**ADDENDUM TO IFB**

IFB Number: **IFB 11-007/KJS**  
IFB Title: **Drainage Improvements to South Central Gardens Area**  
IFB Due: **11:00 AM, February 15, 2011**  
Addendum No.: **# 2**  
Issued (Date): **February 10, 2011**

**ADDENDUM NO. 2**

**CONSTRUCTION OF DRAINAGE IMPROVMENTS TO SOUTH CENTRAL GARDENS**

JEFFERSON COUNTY, TEXAS  
DRAINAGE IMPROVEMENTS  
SOUTH CENTRAL GARDENS AREA  
PLAN & PROFILE FOR  
DIRECTIONAL BORE

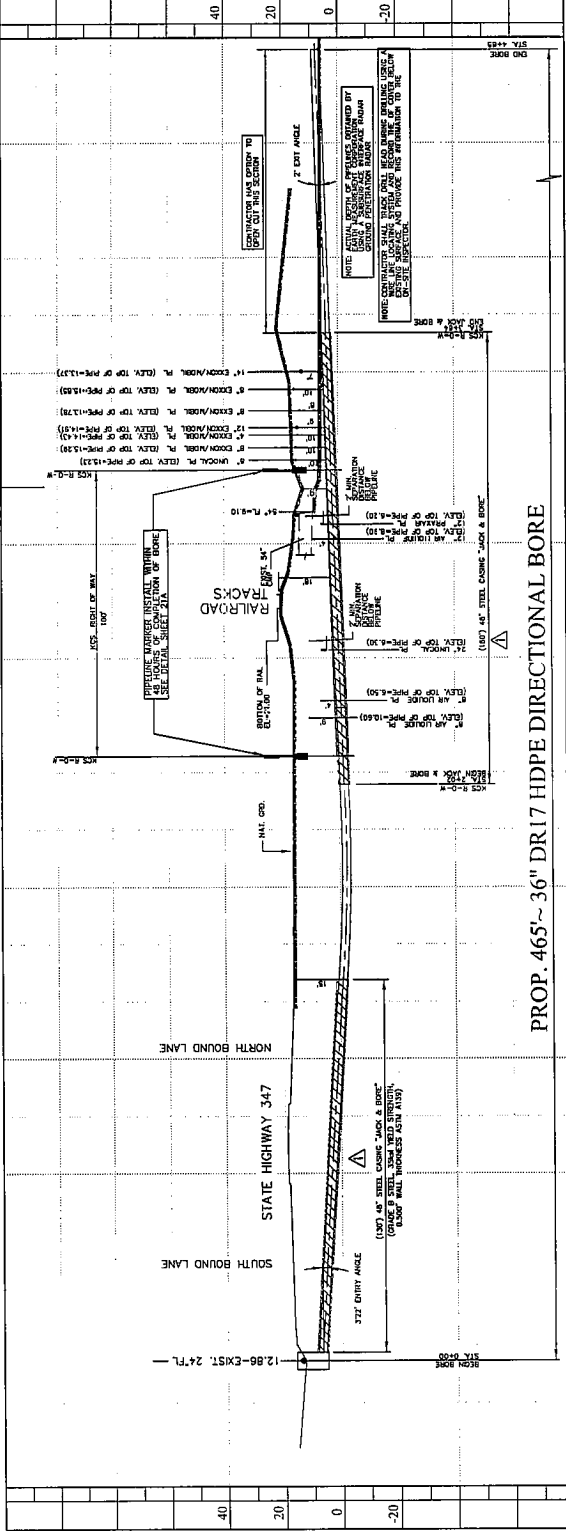
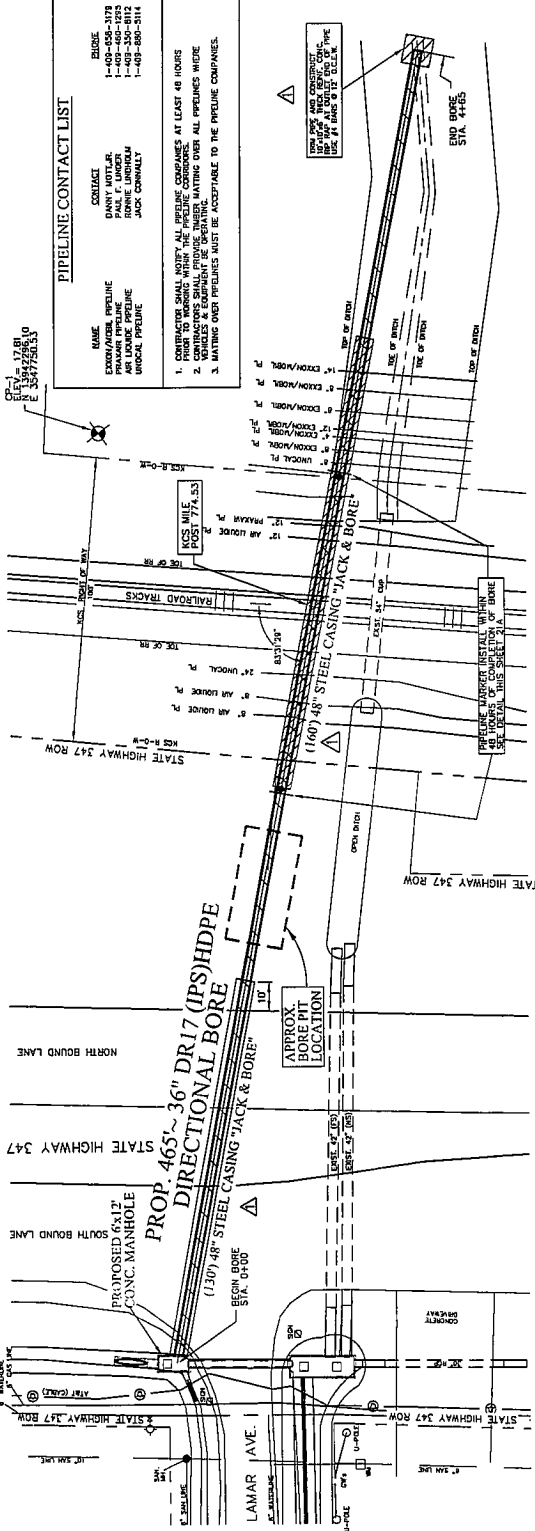
1. **REPLACE Plan Sheet No. 1 with the attached sheet.** This Plan Sheet has been updated to include the current County officials and staff.
2. **REPLACE Plan Sheet Nos. 21 & 21A with the attached sheets.** These Plan Sheets have been updated to incorporate the changes

SCALE	AS SHOWN	DATE	2-8-11
BY	JAL	APPROVED BY	JAL
CHECKED BY	JAL	DATE	2-8-11
DESIGNED BY	JAL	DATE	2-8-11
DRAWN BY	JAL	DATE	2-8-11
PROJECT NO.	JEFFERSON COUNTY, TEXAS DRAINAGE IMPROVEMENTS SOUTH CENTRAL GARDENS AREA DIRECTIONAL BORE DETAILS

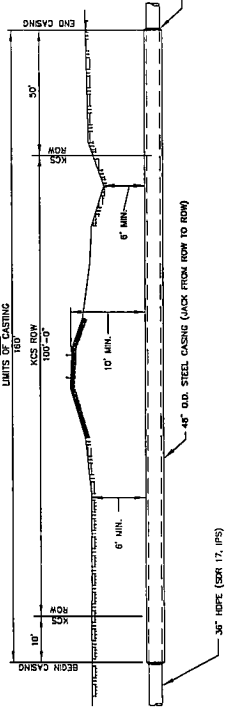
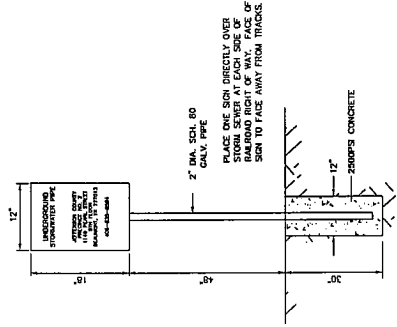
4. **Clarification: Item 476 – Jacking, Boring, or Tunneling Pipe or Box.** This item is a Plans Quantity Measurement. The amount of casing beneath the KCS Railroad ROW, shown on the Plans, has been increased to 160 LF. If the contractor wishes to install additional casing to facilitate construction, it may be done so at no additional expense to the Owner. Plan Sheet 21 shows a "Bore Pit Location". The contractor has the option to relocate the actual bore pit to a location that will facilitate construction of the project, so long as the bore pit is located outside of the KCS right-of-way.

5. **Jack & Bore Additional Casing (Bid Item A7):** ADD 130LF of 48-inch diameter steel casing. Casing shall be **0.500-inch wall thickness**, Grade B Steel, with a minimum Yield Strength of 35 ksi, ASTM A139, including wrap-around end seals similar to those proposed for use on the KCS bore. Please note that the wall thicknesses of the casing pipes are not similar to each other.

TCP(2-1)-98 MODIFIED

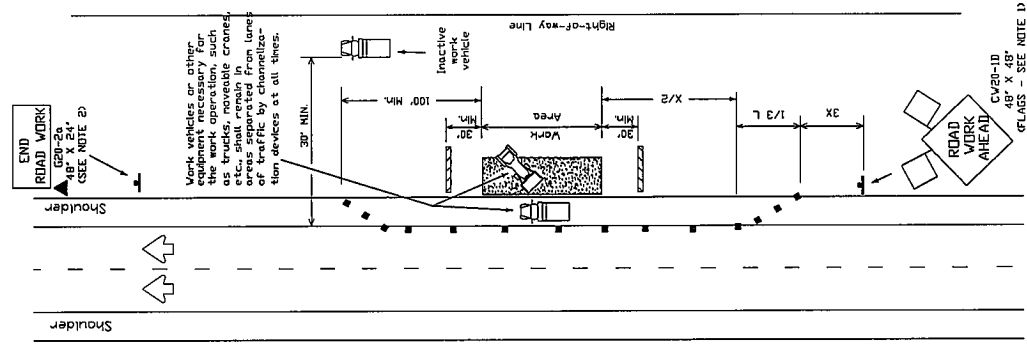
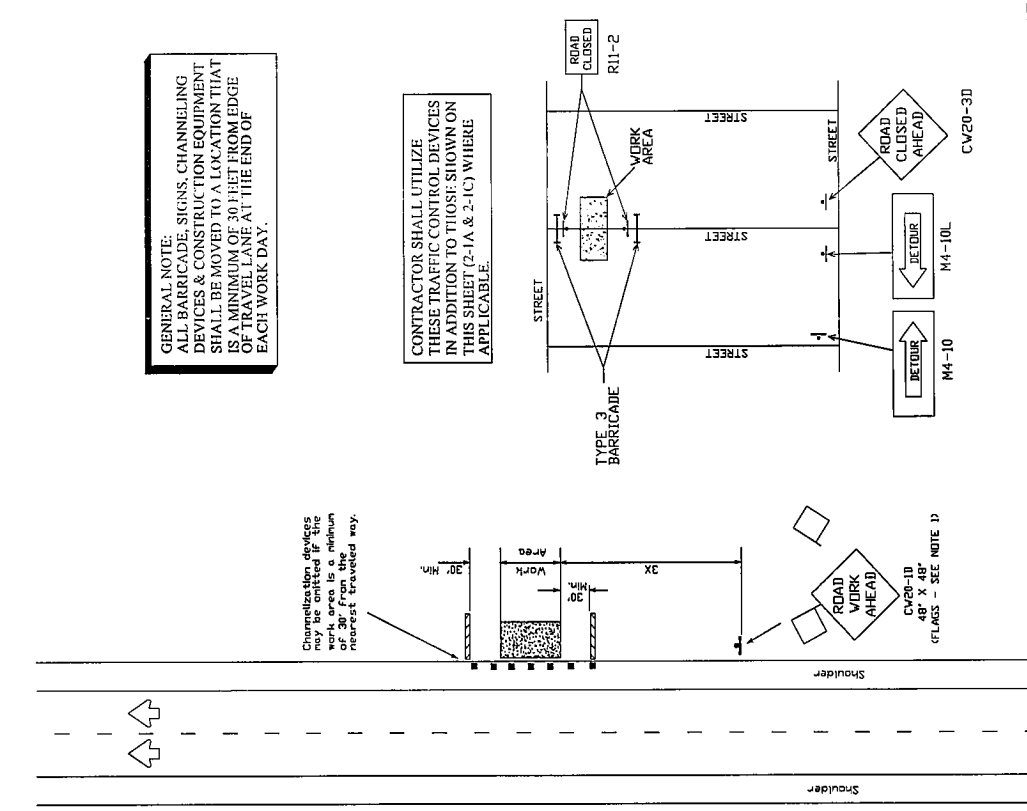
3. **ADD Traffic Control Plan Sheet 27, "TCP(2-1)-98 MODIFIED"** to the contract documents. Payment for this item shall be in accordance with **Bid Items A5 & A6** which have been included in the new Bid Forms described below.
